## Site Evaluation Criteria - Circulation

Willows Crossing  
or  
Willows Crashing?

# Summary - PDP to southbound Pfingsten

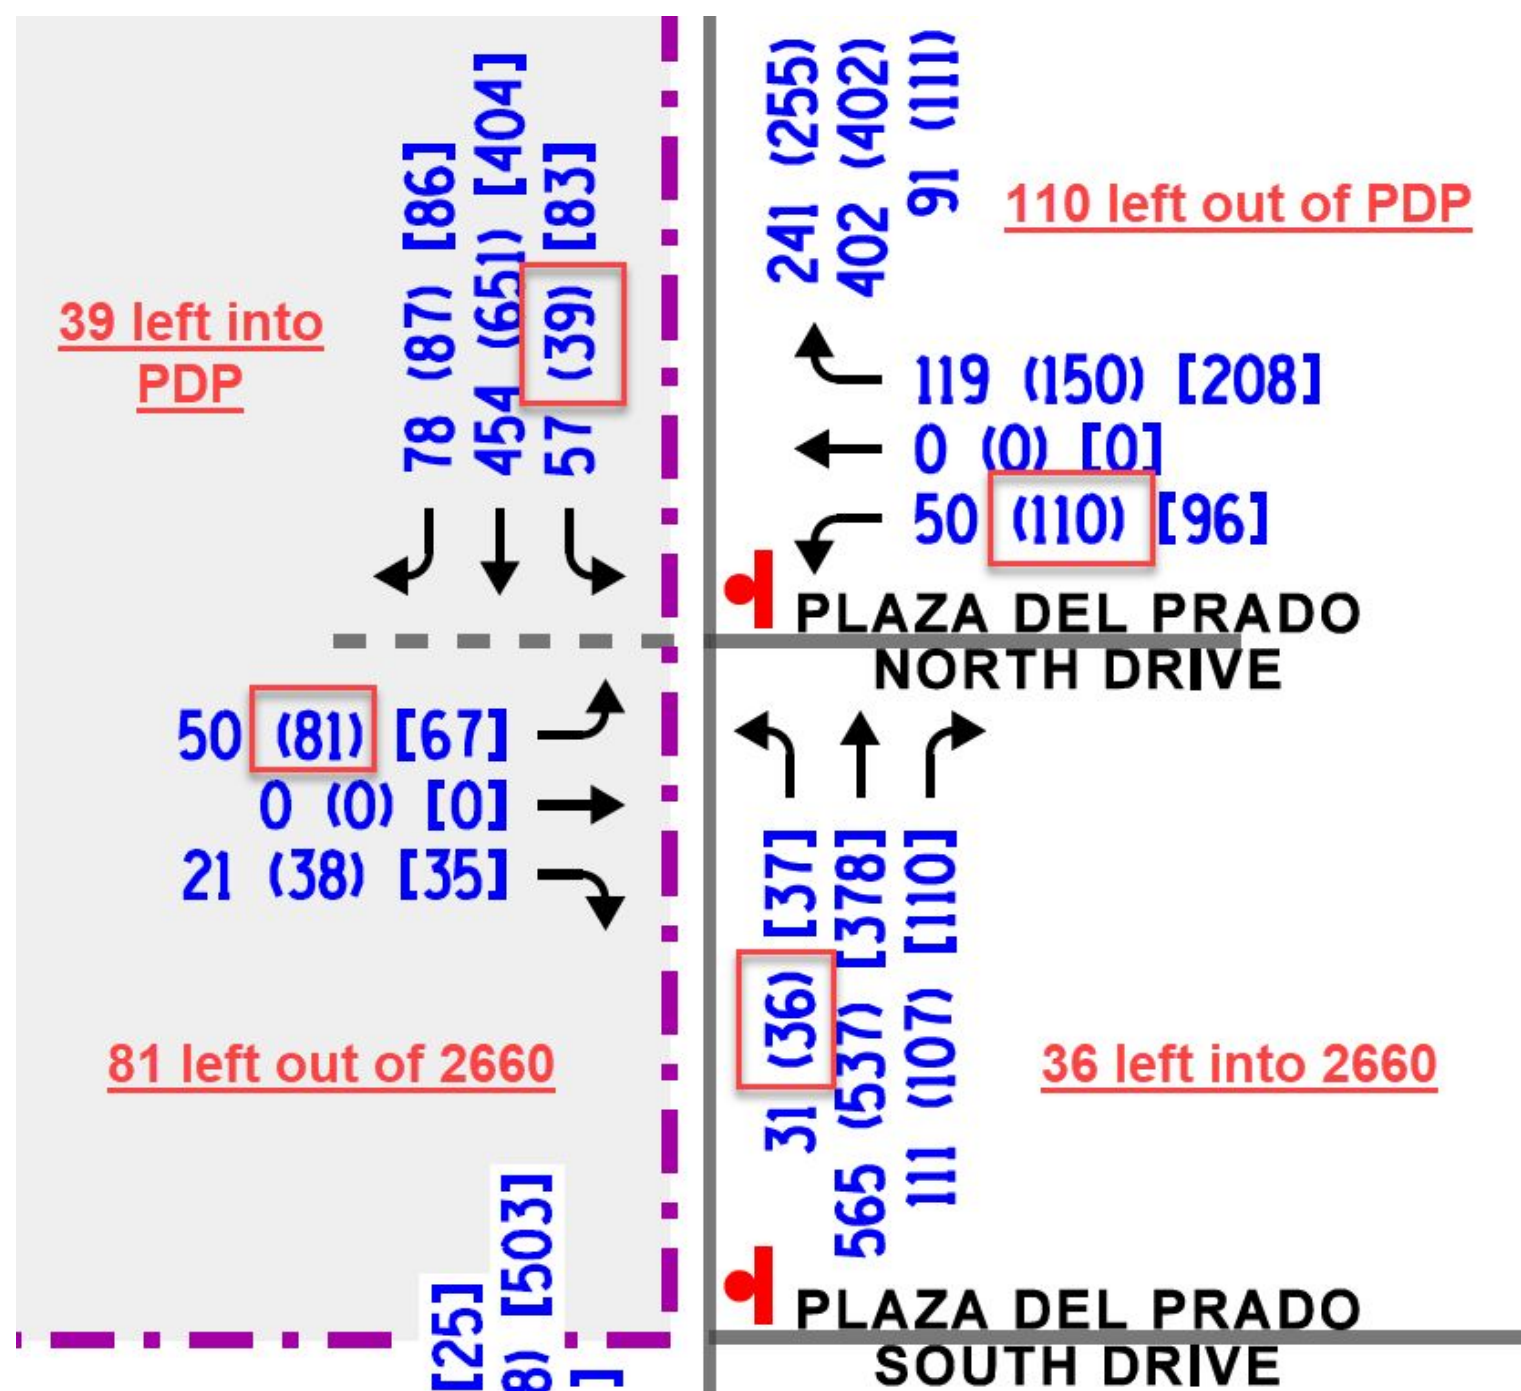
By 2028 the time to exit Plaza del Prado to go southbound on Pfingsten will increase **3x (42 -> 139 seconds)** with more than double the cars (**3-> 7**) queuing to exit

266 conflicting left  
turns without a  
traffic signal

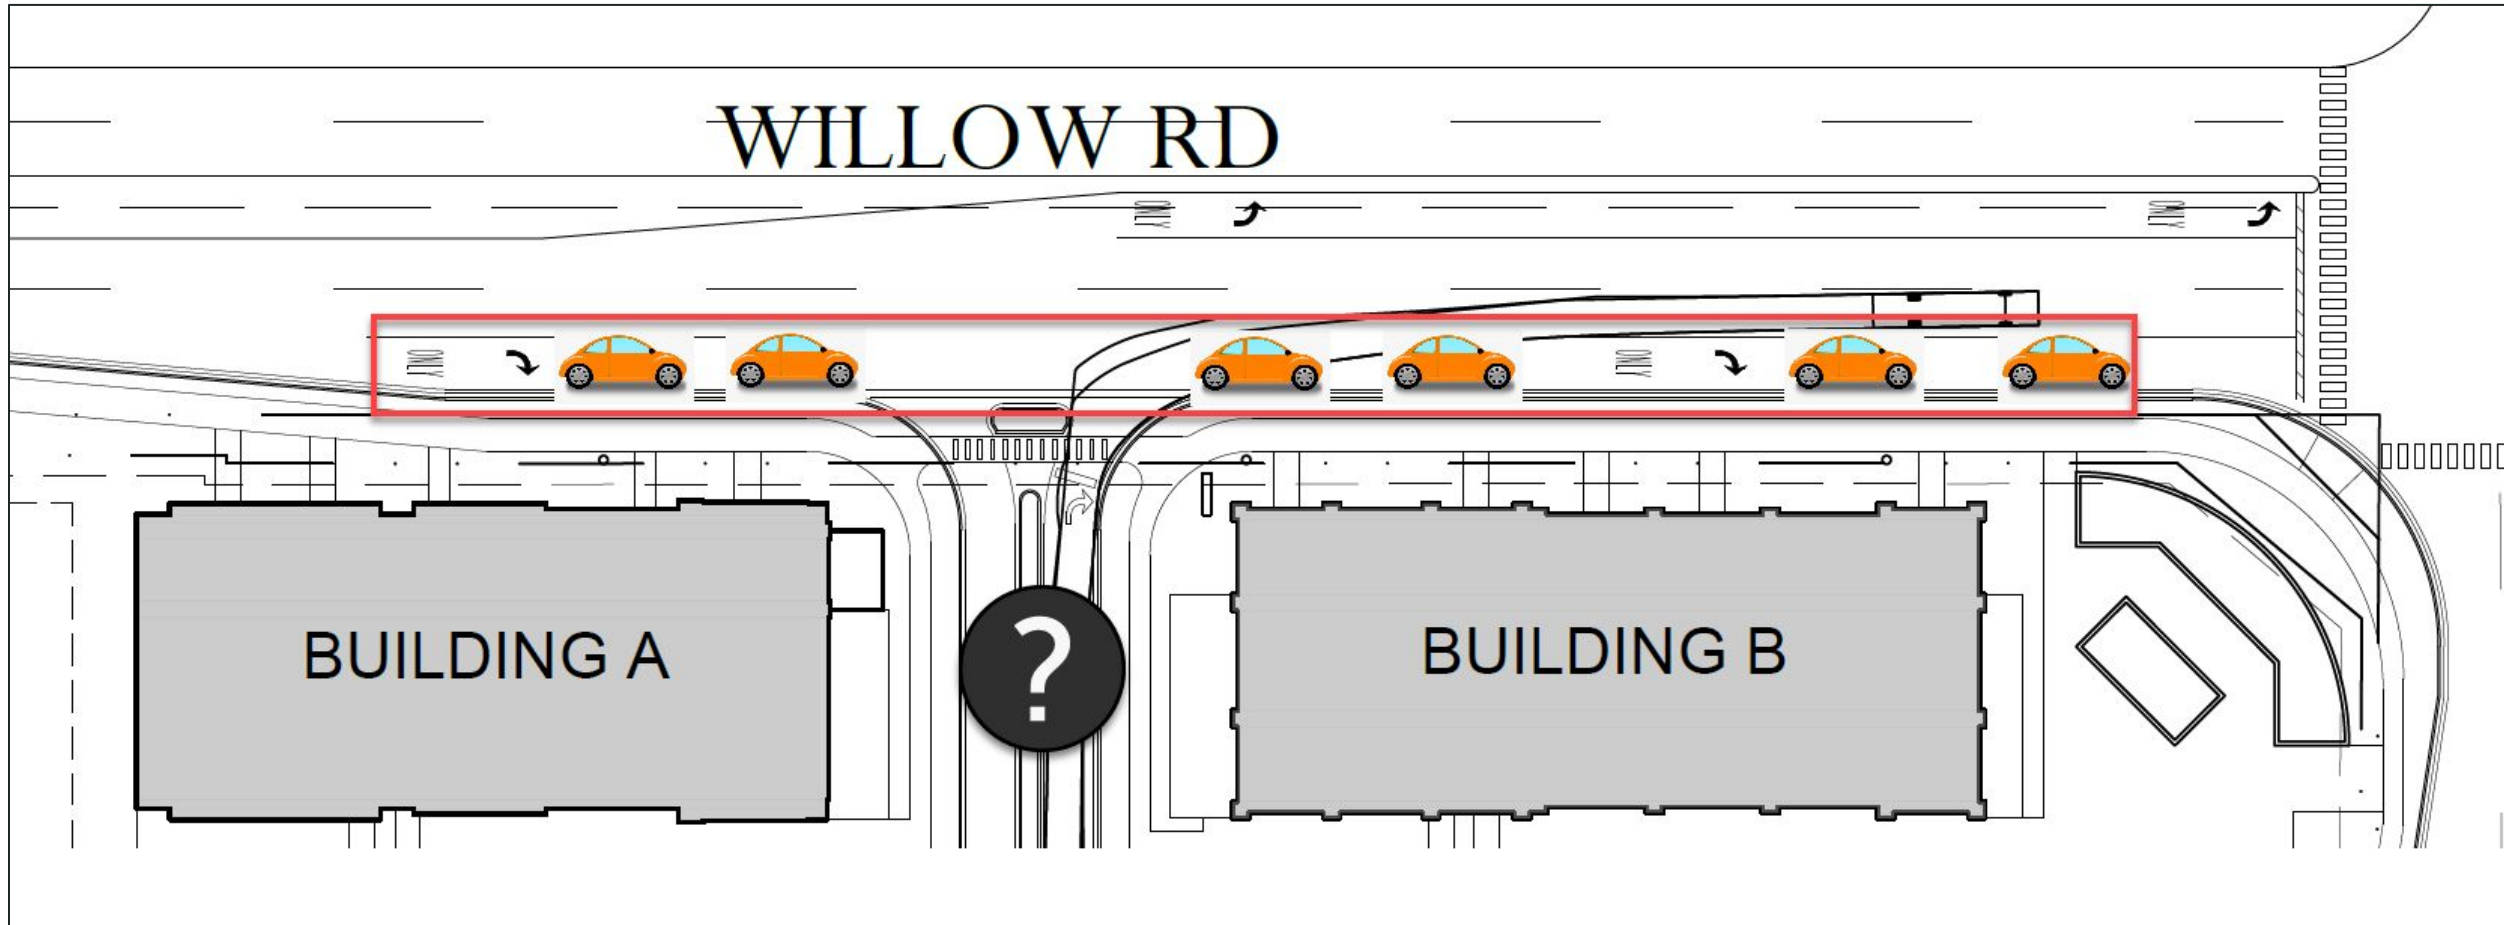
Unclear if a driver is turning into 2660 or south on Pfingsten

# Fire truck encroaches parked cars near Building B and C

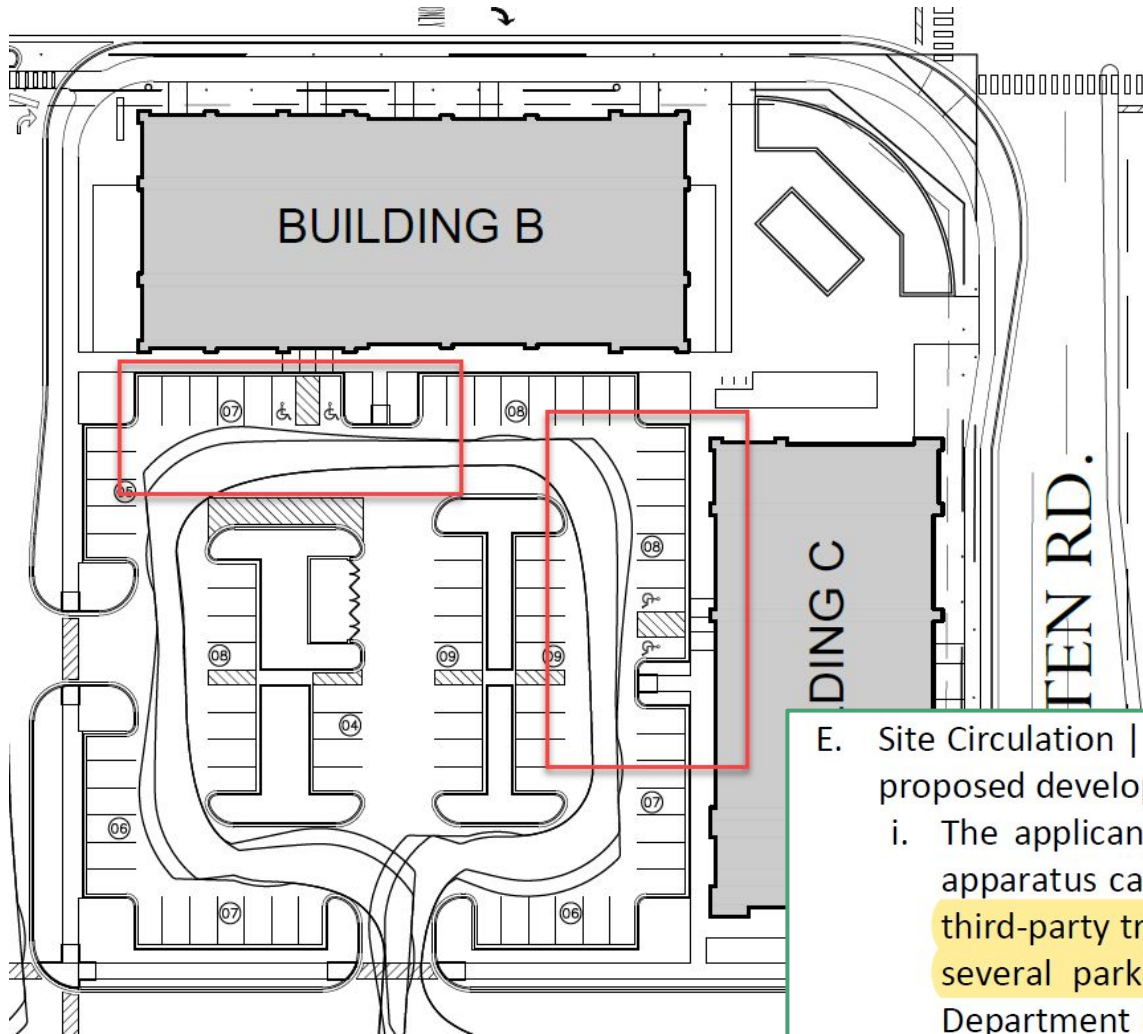
- E. Site Circulation | The following comments relate to the issue of site circulation in regard to the proposed development plans:
- The applicant has provided an exhibit demonstrating that the Village's largest fire truck apparatus can enter and navigate the site from the Pfungsten Road entrance. The Village's third-party traffic engineer has noted that the proposed route encroaches upon the rear of several parking stalls west of the northwest corner of Building C, however the Fire Department has confirmed that the proposed circulation is adequate with sufficient access from adjacent primary drive-aisles.
